RE: Chevron Service Station # 9-0121

Address 3026 Lakeshore Ave., Oakland, CA

Re: **Response to Comments**
Chevron Station 9-0121
3026 Lakeshore Avenue
Oakland, California
Fuel Leak Case No. RO000284

Conestoga-Rovers & Associates (CRA) has prepared this letter report in response to the ACDEH letter, dated July 27, 2007 (Attachment A), on behalf of Chevron Environmental Management Company (Chevron) for the site referenced above. The ACDEH letter requested the following:

Trend Graphs for Wells MW-1 and MW-9

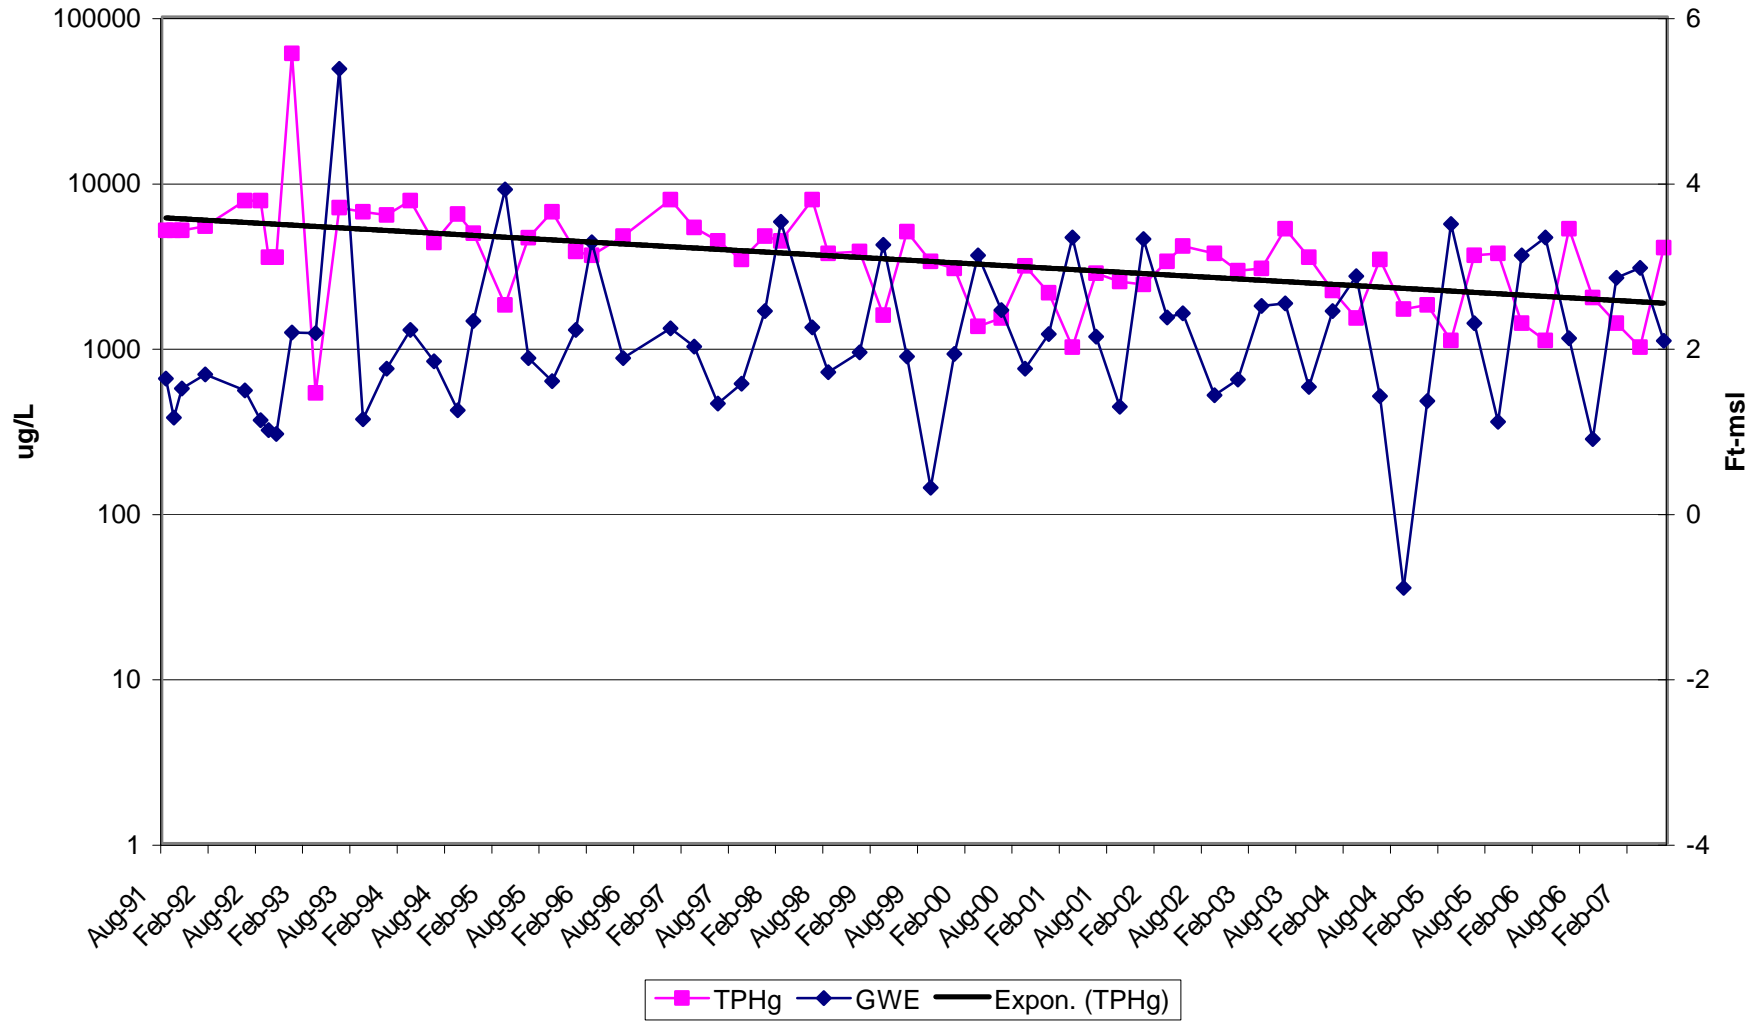
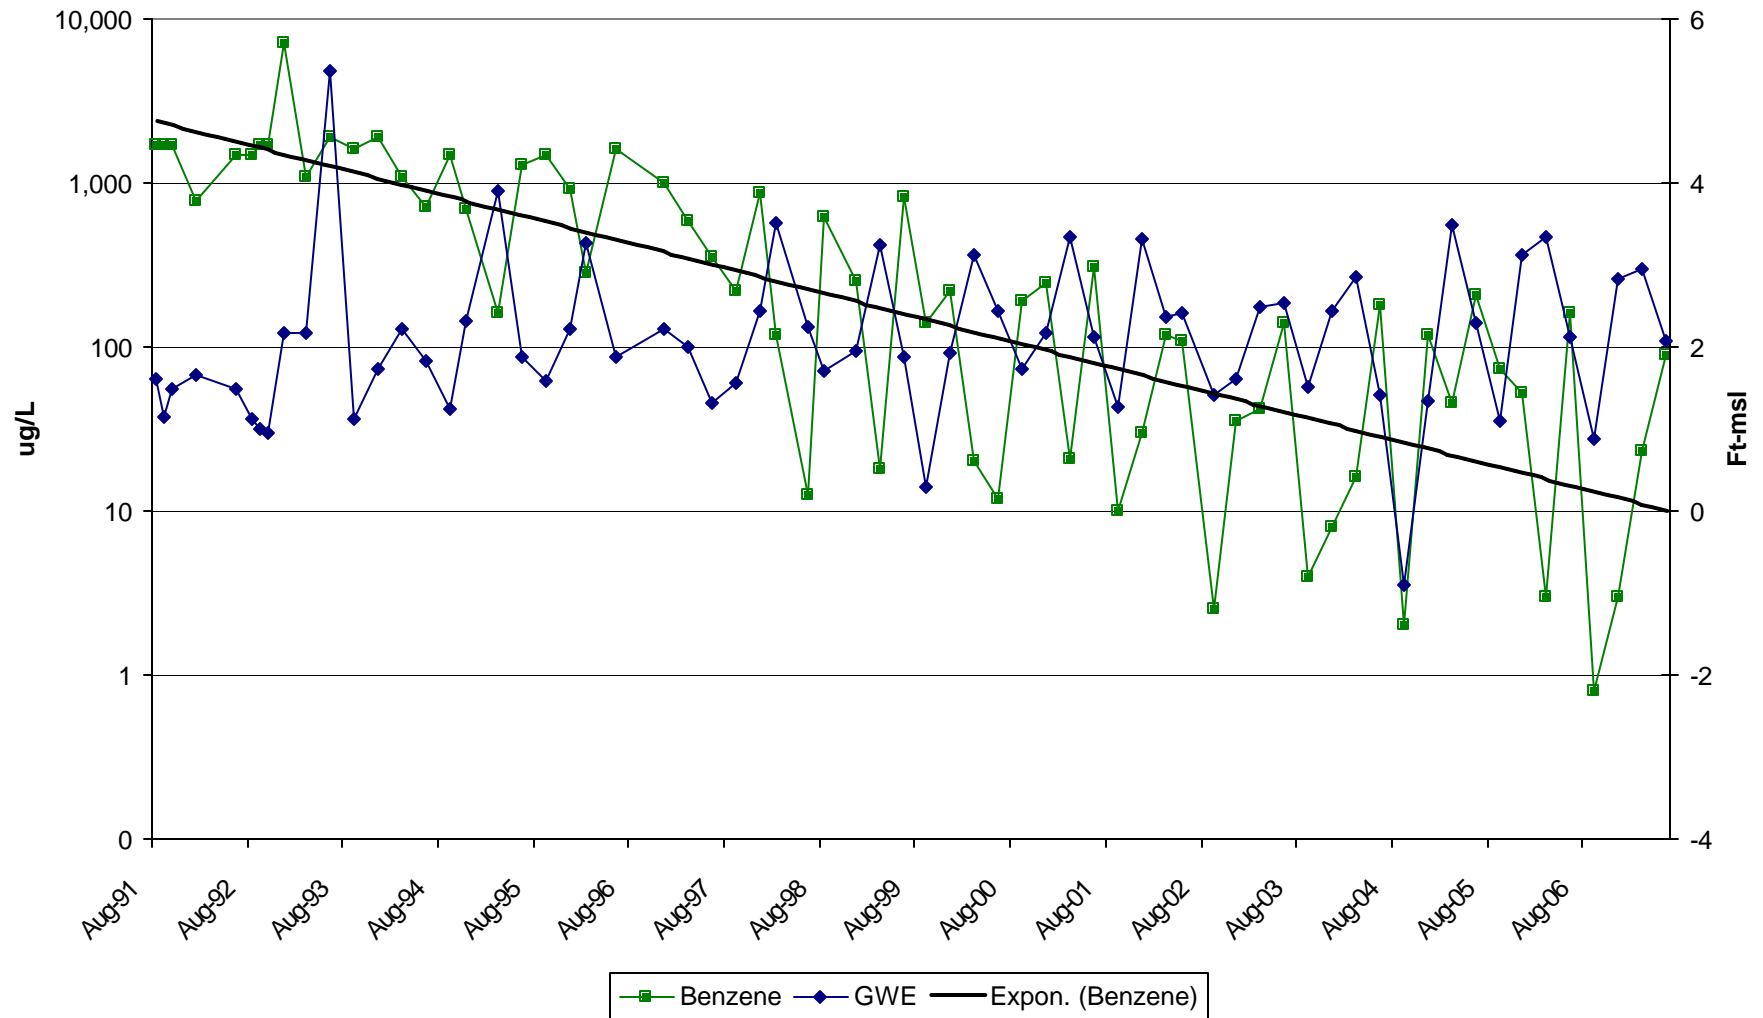
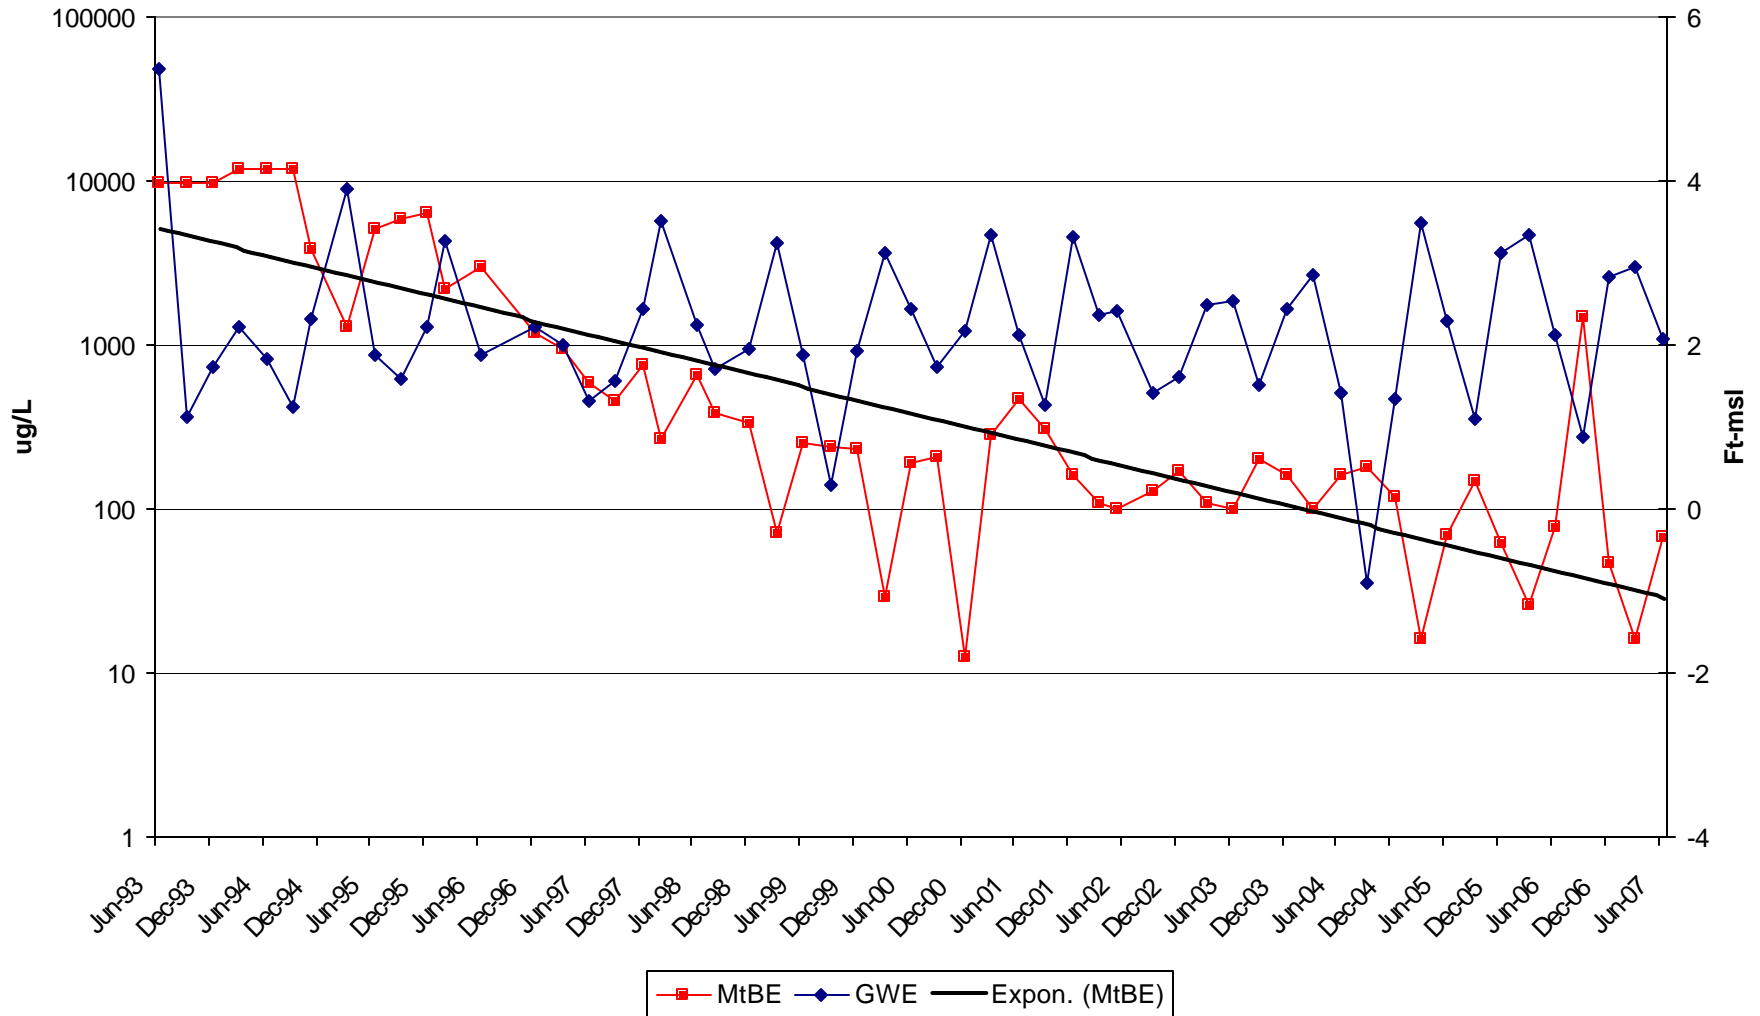
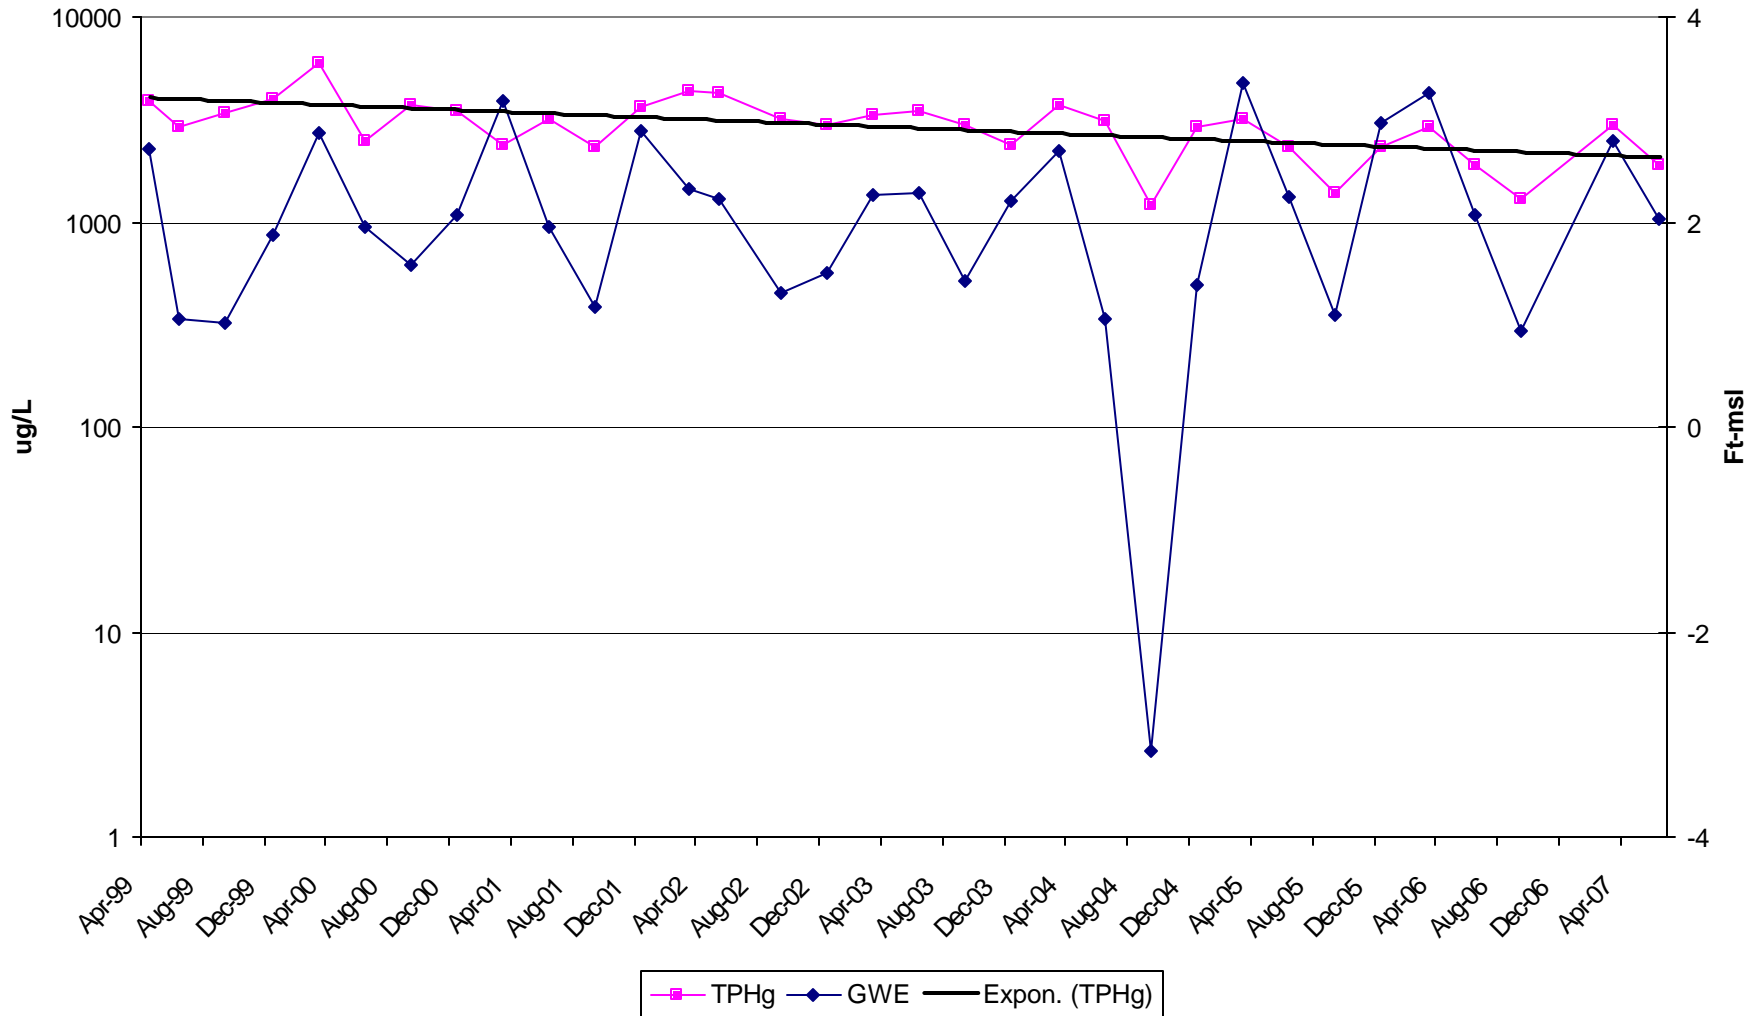
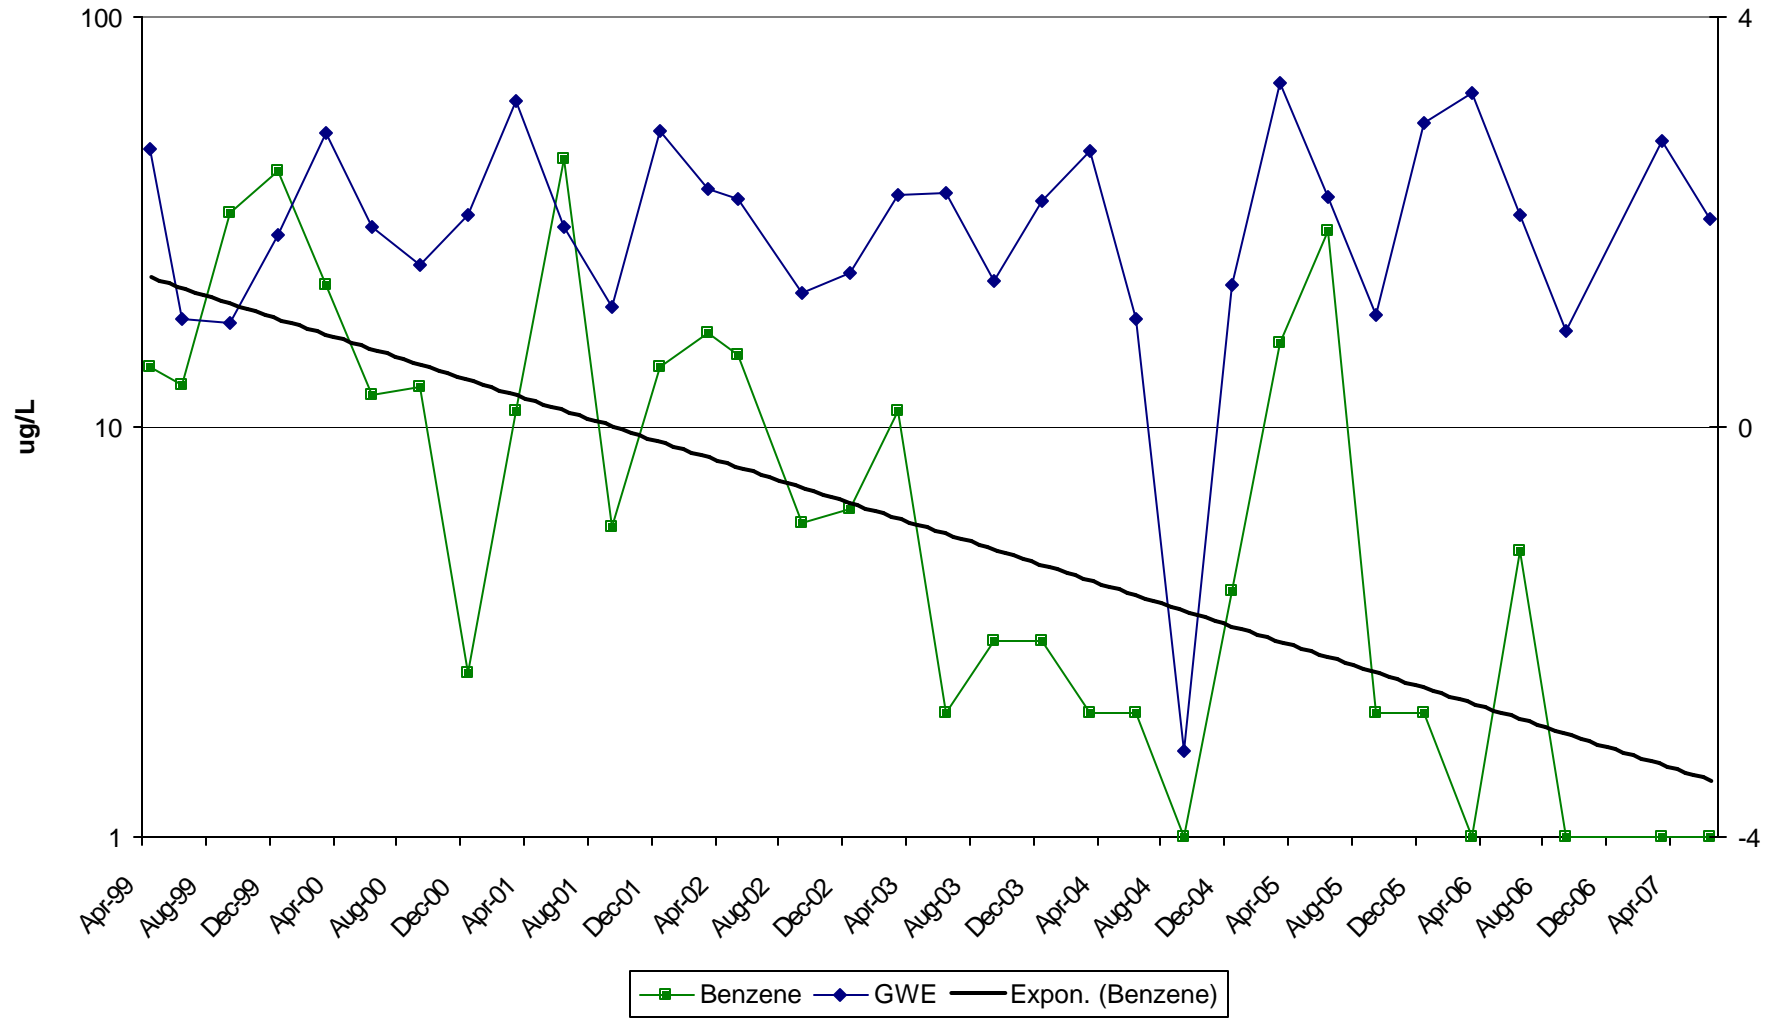
1. Off-site Building Impacts- Our office believes the presence of petroleum contaminated water in the neighboring building sump should be prevented by initiating on-site remediation at your site. Please provide options and your recommendation for remediation. Please verify that the current UST system is currently in compliance by contacting the OFD and reviewing the latest inspection reports for these USTs. Please submit these reports as requested below.
2. MW-7 Status- Monitoring well MW-7 has either been unable to be located or paved over for a long period of time. We request that you locate and properly decommission this well as it has and does not add any additional information or understanding to the site. Please indicate when this well will be decommissioned.

CRA and Chevron have reviewed the site data and believe that onsite remediation is not necessary due to decreasing hydrocarbon concentration trends observed in onsite wells, including both monitoring wells along the neighboring property line. Trend graphs for wells MW-1 and MW-9 are included in Attachment B.
